M E M O R A N D U M

SUBJECT: Consideration of an Amendment to the Clean Water Plan for the Cuyahoga Valley Interceptor (CVI) Facilities Planning Area (FPA) to modify the FPA boundary and wastewater treatment prescription for the Cuyahoga Valley National Park's Environmental Education Center

RESOLUTION OF THE GENERAL POLICY BOARD OF THE NORTHEAST OHIO FOUR COUNTY REGIONAL PLANNING AND DEVELOPMENT ORGANIZATION (NEFCO) APPROVING AN AMENDMENT TO THE CLEAN WATER TO MODIFY THE FACILITIES PLANNING AREA BOUNDARY AND WASTEWATER PRESCRIPTION FOR THE CUYAHOGA VALLEY ENVIRONMENTAL EDUCATION CENTER IN SUMMIT COUNTY

Figure 3

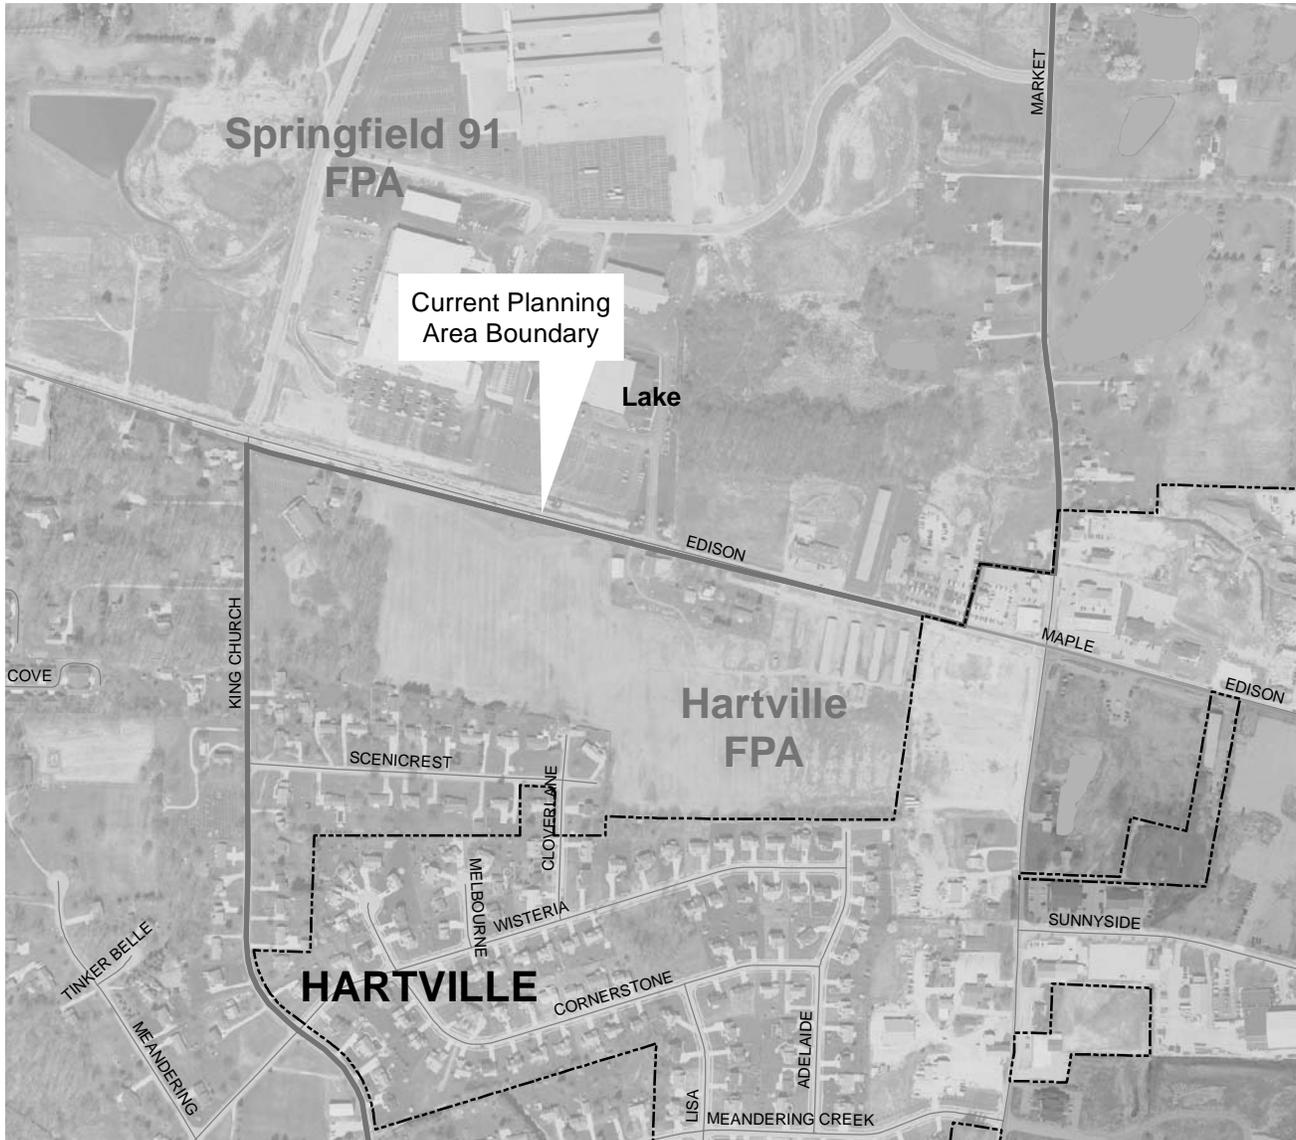
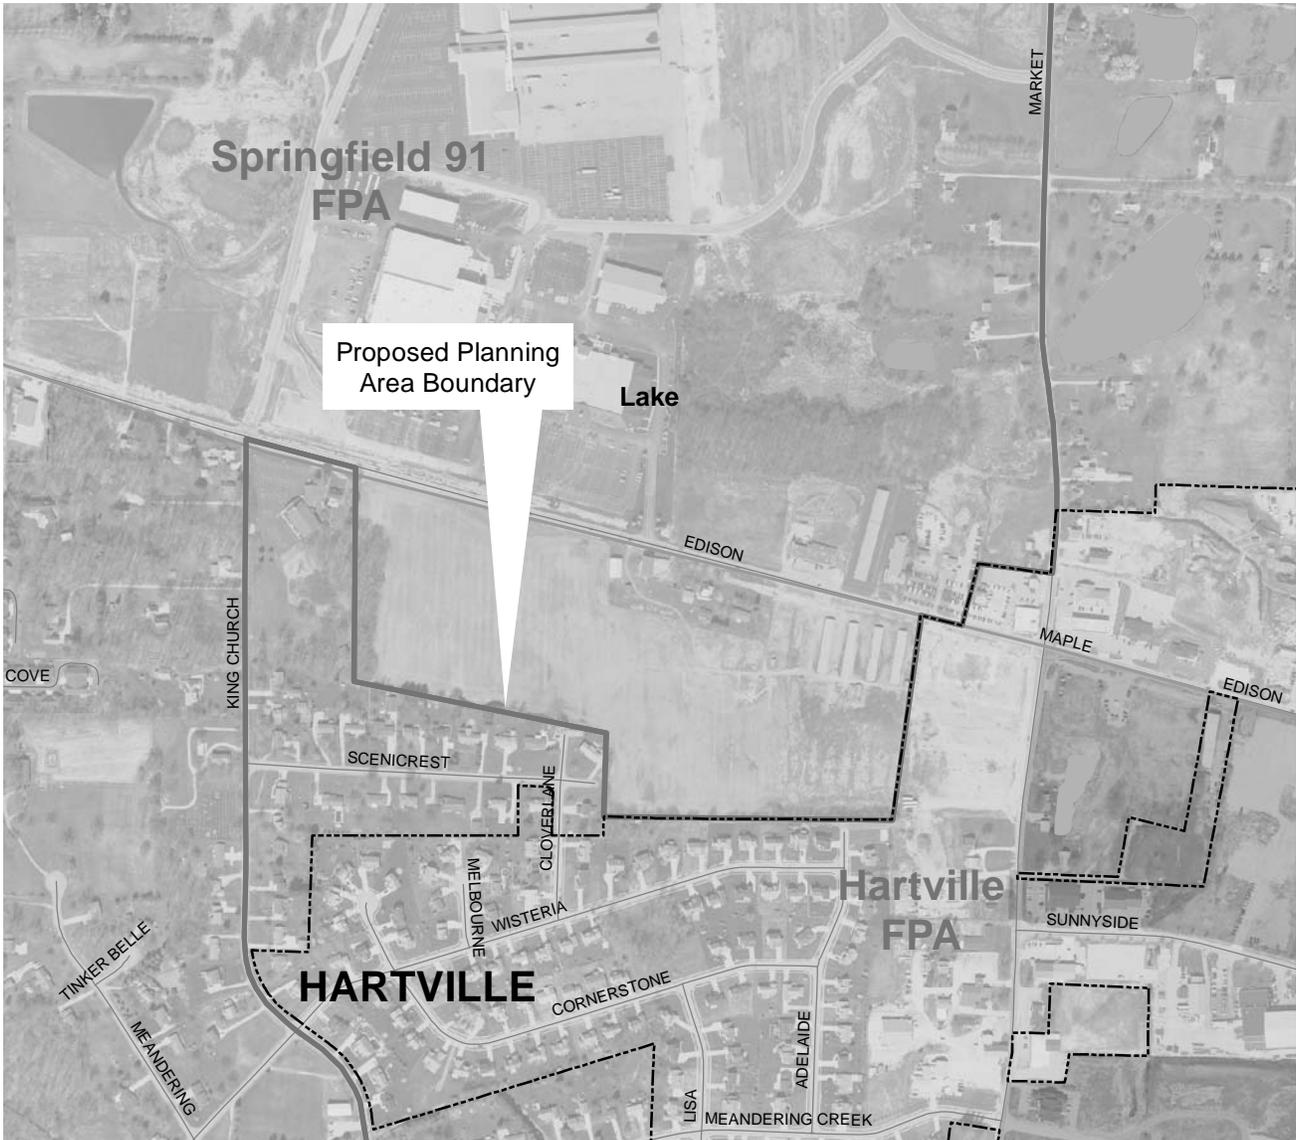
The intent of this amendment is that a portion of the planning area boundary between the Hartville FPA and the Springfield No. 91 FPA be adjusted, generally, to the south of Edison Street across from the Hartville Kitchen Restaurant. This adjustment, located in SE Quarter of Section 9 and SW Quarter of Section 10 in Lake Township, would result in approximately 35 acres being transferred from the Hartville FPA to the Springfield No. 91 FPA. Figure 2 shows the current FPA boundary line for the amendment area and Figure 3 represents the FPA boundary line adjustment proposed by the Stark County MSD.
